Product Change Notice (PCN)

PCN Number: PCN-0451152R-01

Product(s) Affected: PJ-038A, PJ-038B, PJ-038AH, PJ-038BH

Current version	New version
Outlook		
Front

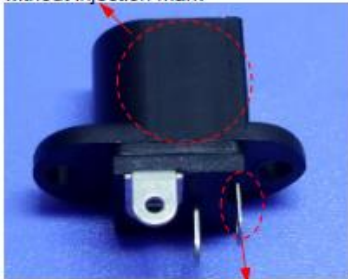
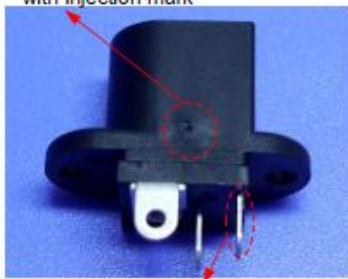
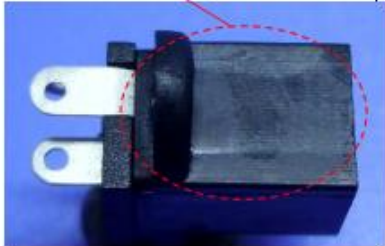
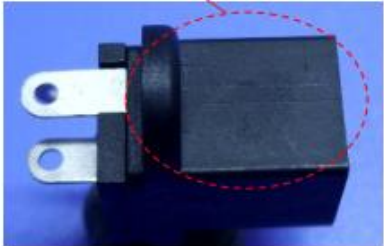
Description of Change: Thickness of pin 2 changed from 0.2mm to 0.25mm. Aesthetic changes as shown in below comparisons:

Back	<p>cave marking location</p>  <p>cave marking location</p>	<p>cave marking location</p>  <p>cave marking location</p>
Top	<p>without injection mark</p>  <p>thickness of pin#2 is 0.2mm</p>	<p>with injection mark</p>  <p>thickness of pin#2 is 0.25mm</p>
Bottom	<p>rough surface</p>  <p>with injection mark</p>	<p>smooth surface</p>  <p>with injection mark</p>

Right	<p>rough surface</p> 	<p>smooth surface</p> 
Left	<p>rough surface</p> 	<p>smooth surface</p>
